STATE OF MAINE
DEPARTMENT OF TRANSPORTATION
16 STATE HOUSE STATION
AUGUSTA, MAINE 04333-0016

January 19, 2023
Subject: Acadia Gateway
State WIN: 017163.03
Location: **Trenton**
Amendment No. 5

Amendment #5 Updates
 -Added details 8,9

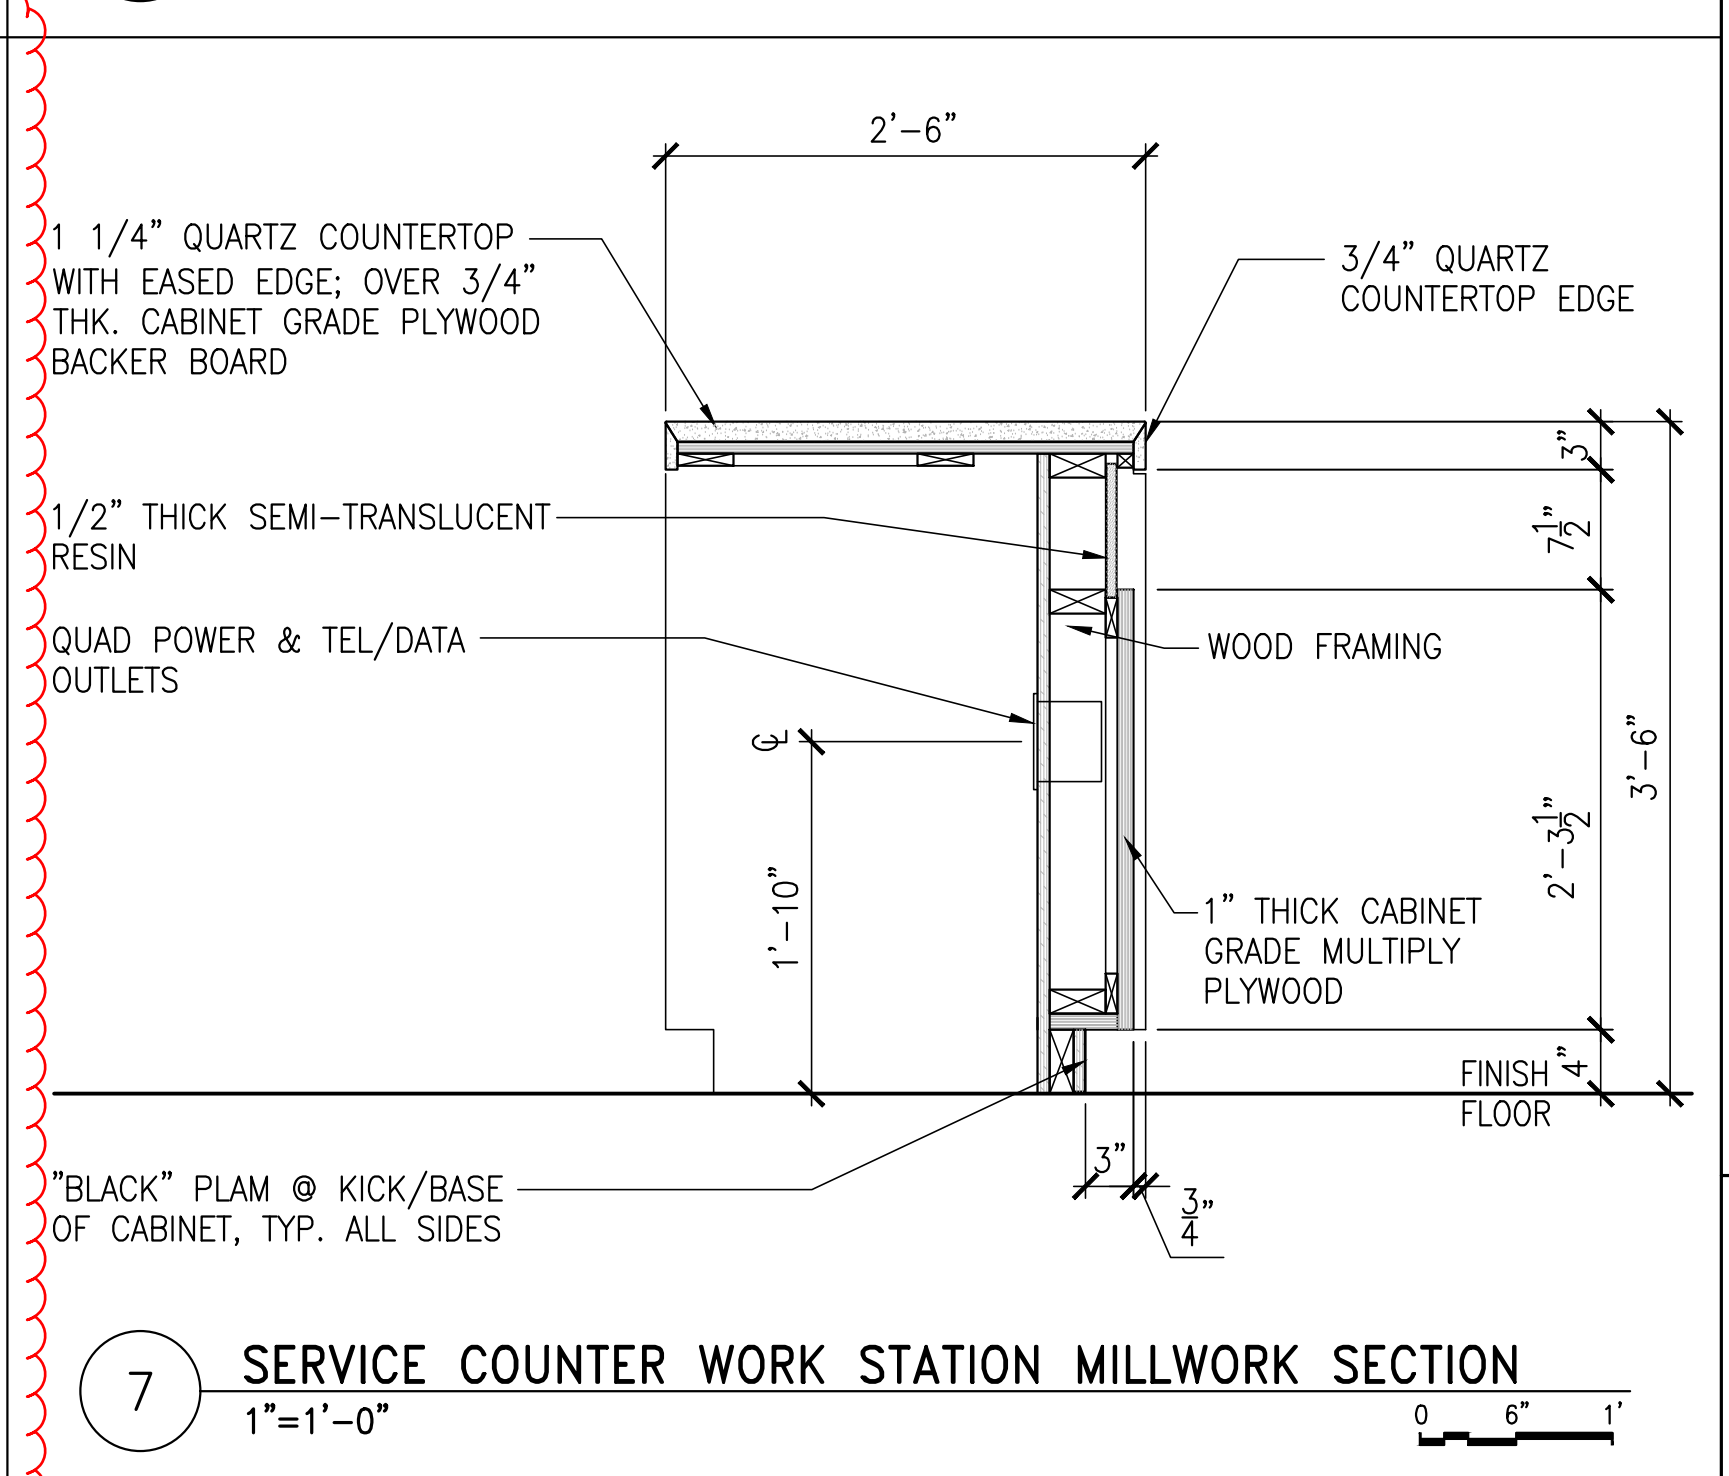
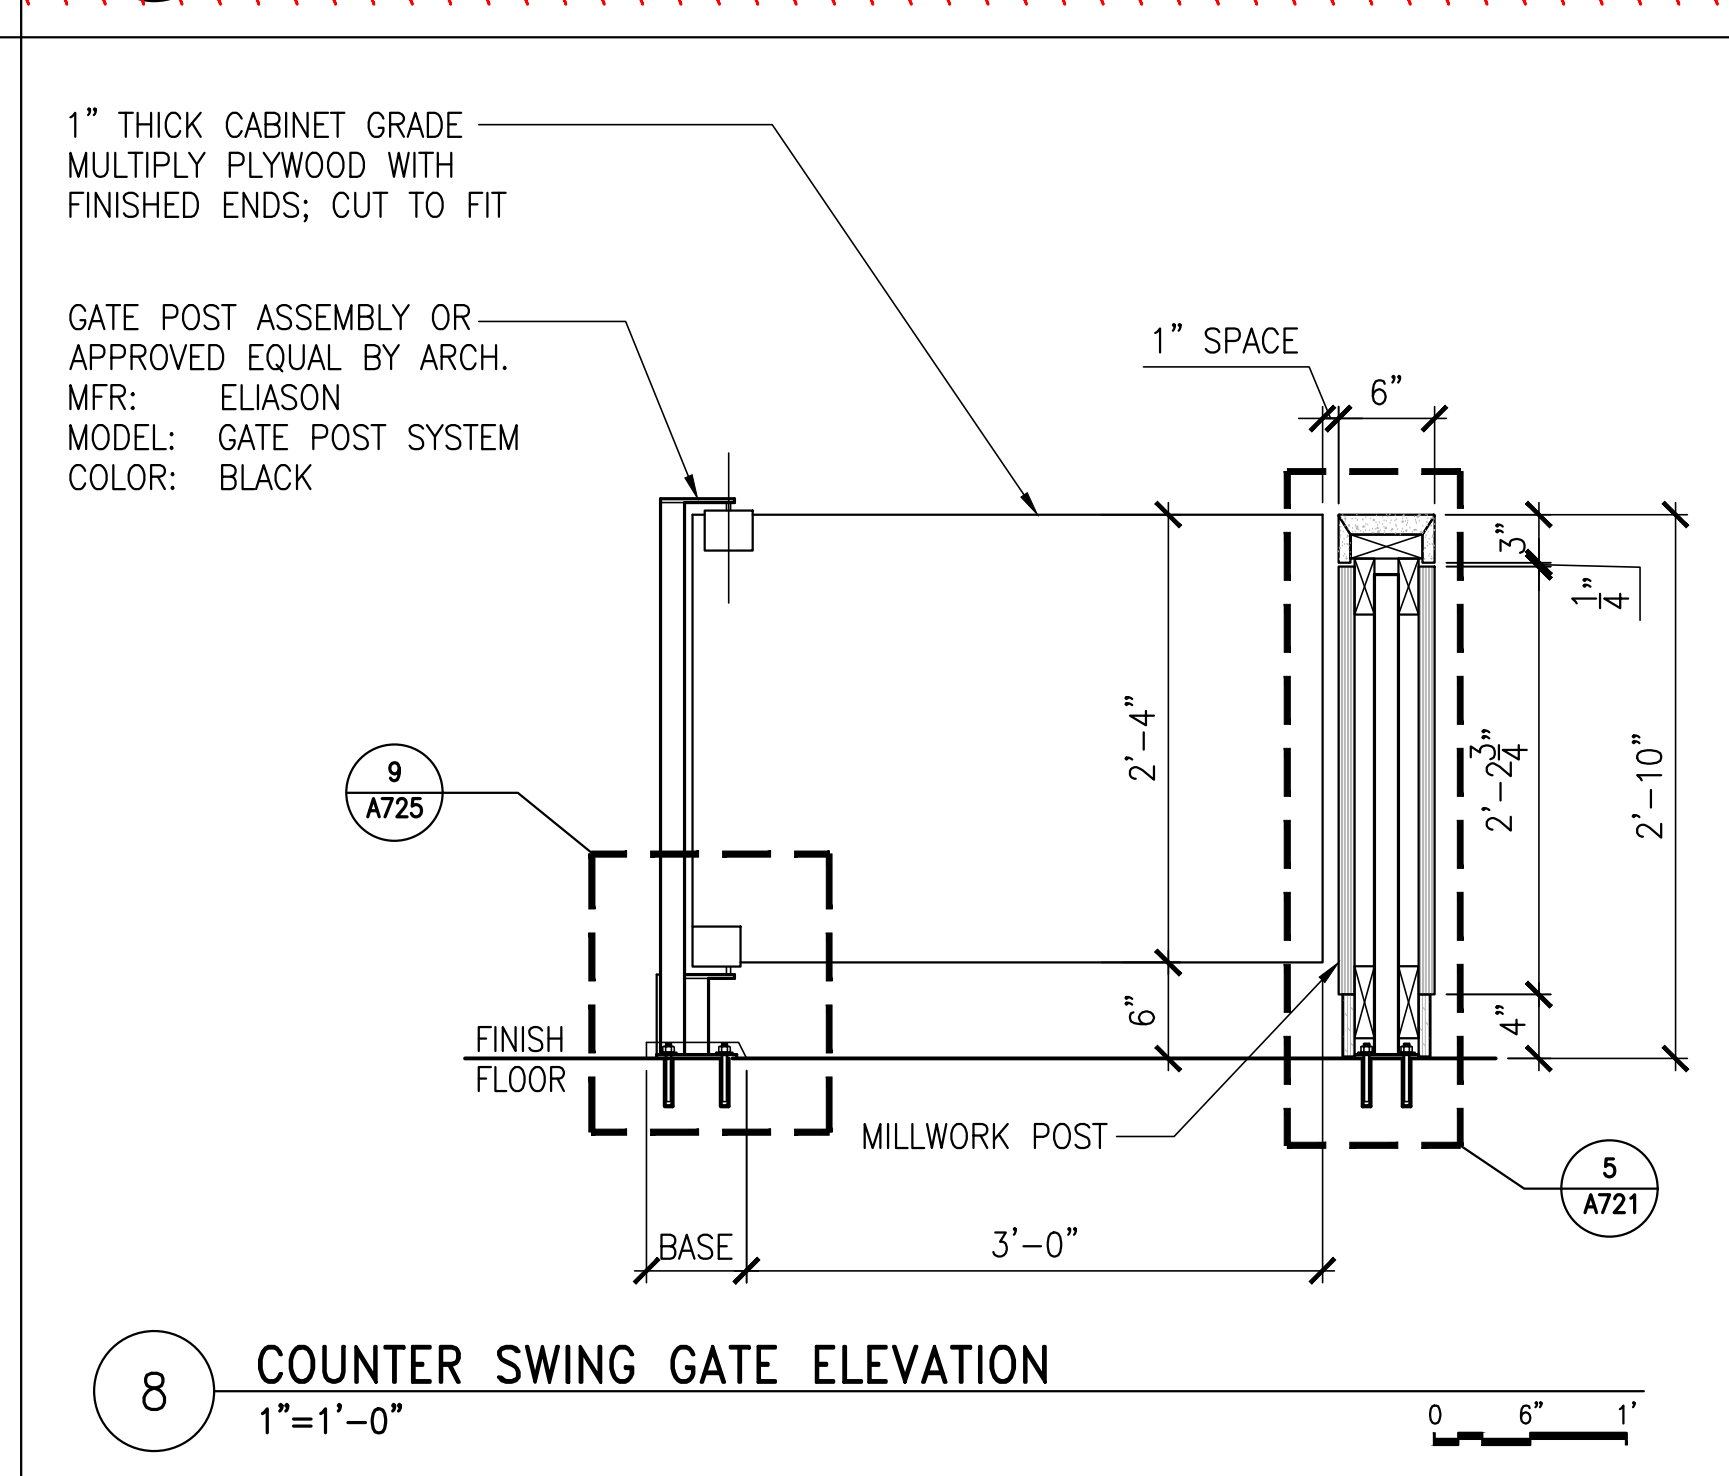
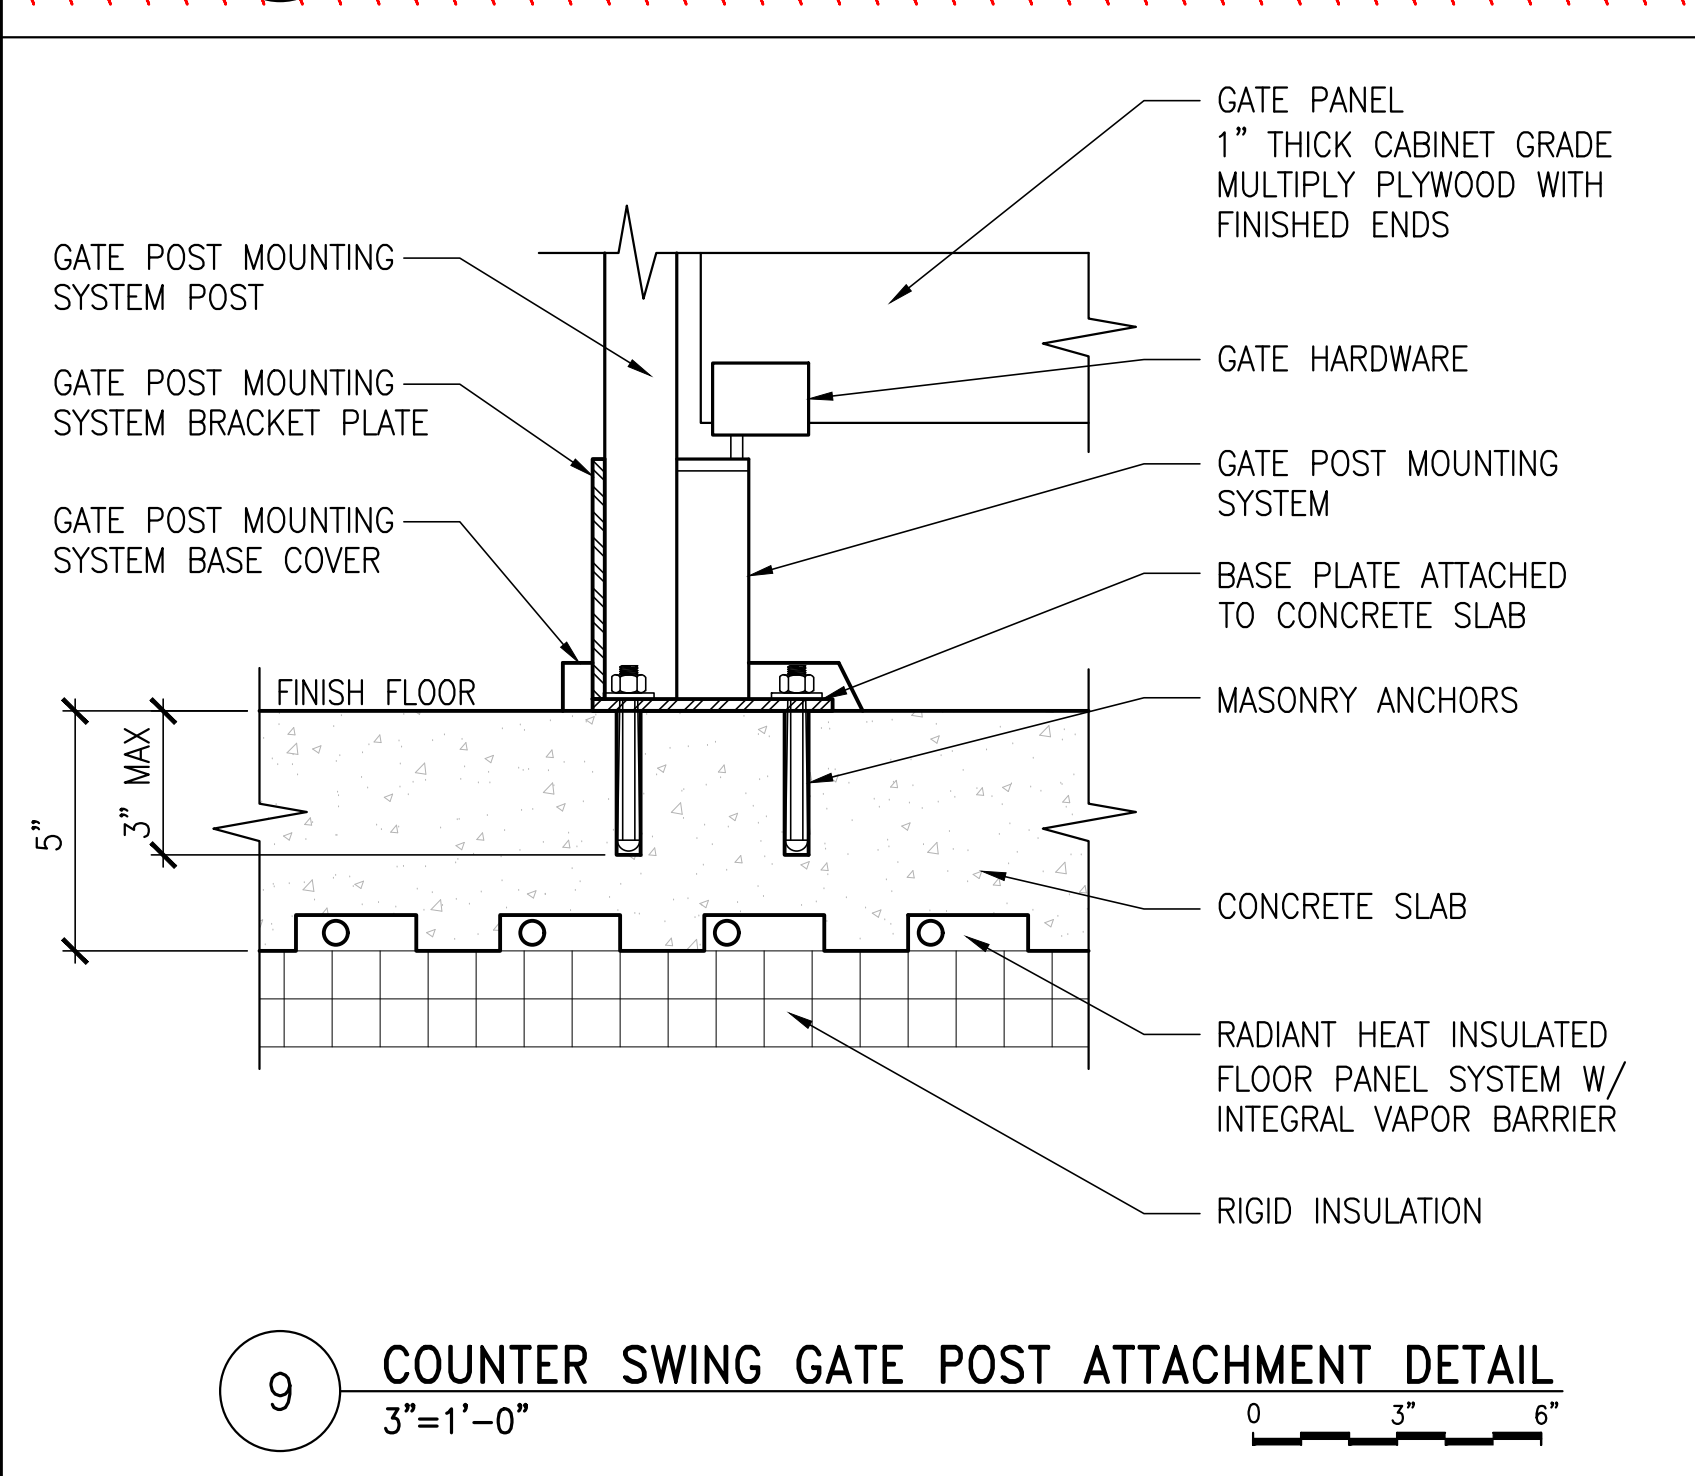
Question: There is a note about 2 counters/gates/panels at MW-03, Rm.#113 listed as TBD. Are details coming?

Response: Details for the two swing gates have been added to the drawings in Amendment #5. Sheets A202, A702, A703, A715, A721, A725 have been updated.
